J AND R SUBDIVISION

APPLICATION NUMBER 1 DATE March 19, 2015

REQUEST Subdivision

DETAIL SITE PLAN

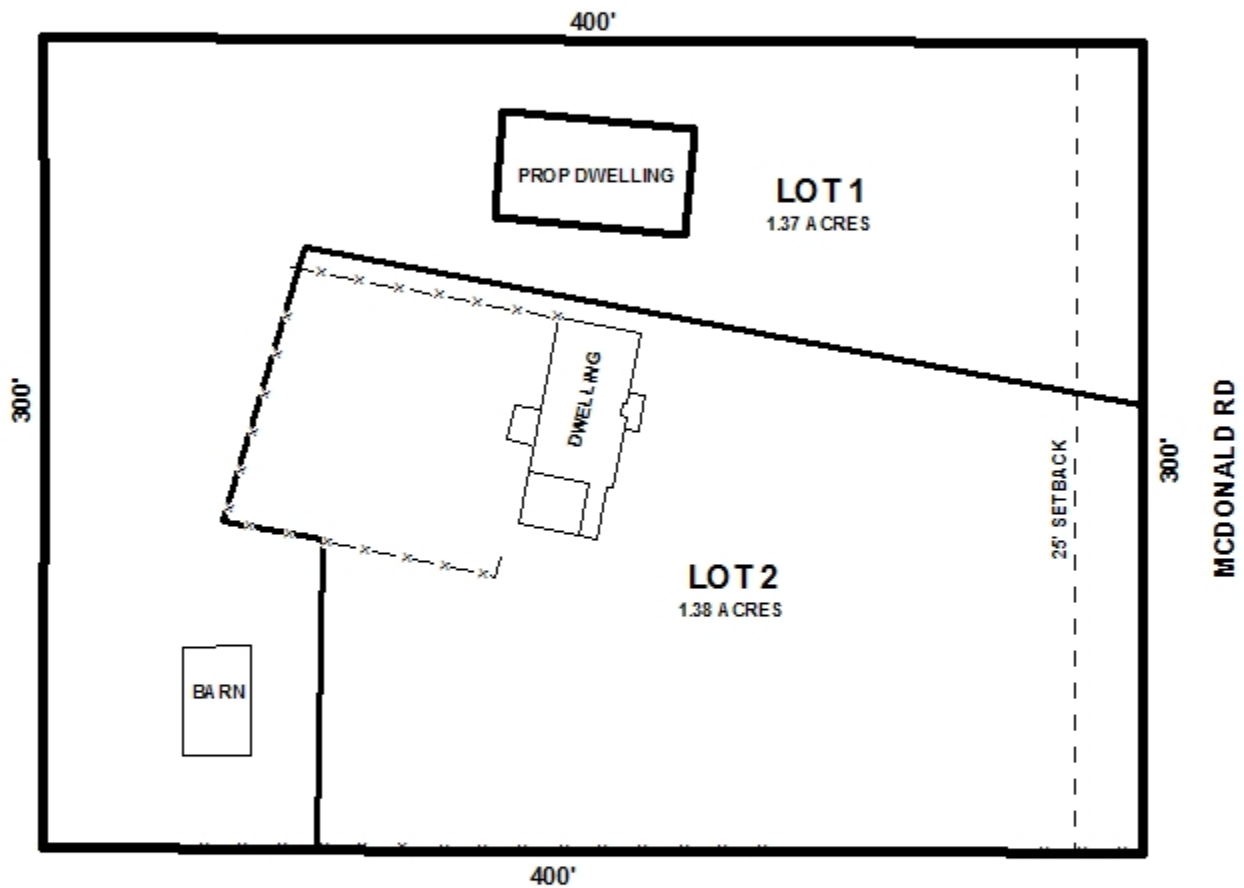
In accordance with the Subdivision Regulations, both proposed lots appear to exceed the minimum lot size requirements, and the 25' minimum building setback line is depicted on the preliminary plat and should be retained on the Final Plat, if approved.

Lot 1 is oddly shaped, and as such, will require a waiver of Section V.D.1 of the Subdivision Regulations. It appears that the lot shape is such to accommodate the existing dwelling and pool on Lot 2, and to allow Lot 1 to incorporate an existing barn into the lot. As there are other oddly shaped lots in the vicinity that have been approved by the Planning Commission, a waiver of Section V.D.1 may be appropriate.

The proposed lots front McDonald Road, a planned major street as shown on the Major Street Plan Component of the Comprehensive Plan. This street requires a 100' right-of-way width; however, the existing right-of-way width only measures 30' from centerline. As such, dedication, sufficient to provide 50' from the centerline of McDonald Road should be required. The lot size information and 25' minimum building setback line should be revised on the Final Plat to reflect dedication. The minimum right-of-way width of McDonald Road, adjacent to the site, is not shown on the preliminary plat but should be depicted on the Final Plat, if approved.

As a means of access management, a note should be placed on the Final Plat stating that the proposed Lot 1 is limited to 1 curb-cut to McDonald Road and the proposed Lot 2 should be limited to the existing curb-cut to McDonald Road. The size, design and location of the new

curb-cut and any changes to the existing curb-cut are to be approved by Mobile County Engineering and conform to AASHTO standards.

Due to the odd shape of Lot 1, a note should be placed on the Final Plat stating that there shall be no additional subdivision until frontage on a public or compliant private street is provided.

With a waiver of Section V.D.1 of the Subdivision Regulations, the application is recommended for tentative approval, subject to the following conditions:

- 1) Dedication sufficient to provide 50' from the centerline of McDonald Road;
- 2) Revision of the lot size information and 25' minimum building setback line on the Final Plat to reflect dedication;

- 3) Revision of the Final Plat to depict the minimum right-of-way width of McDonald Road, adjacent to the site;
- 4) Placement of a note on the Final Plat stating that Lot 1 is limited to 1 curb-cut to McDonald Road, with the size, design or location to be approved by Mobile County Engineering and conform to AASHTO standards;

- 5) Placement of a note on the Final Plat stating that Lot 2 is limited to the existing curb-cut to McDonald Road, with any changes to the size, design and location to be approved by Mobile County Engineering and conform to AASHTO standards;

- 9) Placement of a note on Final Plat stating no future subdivision of Lot 1 until frontage on a public or compliant private street is provided.
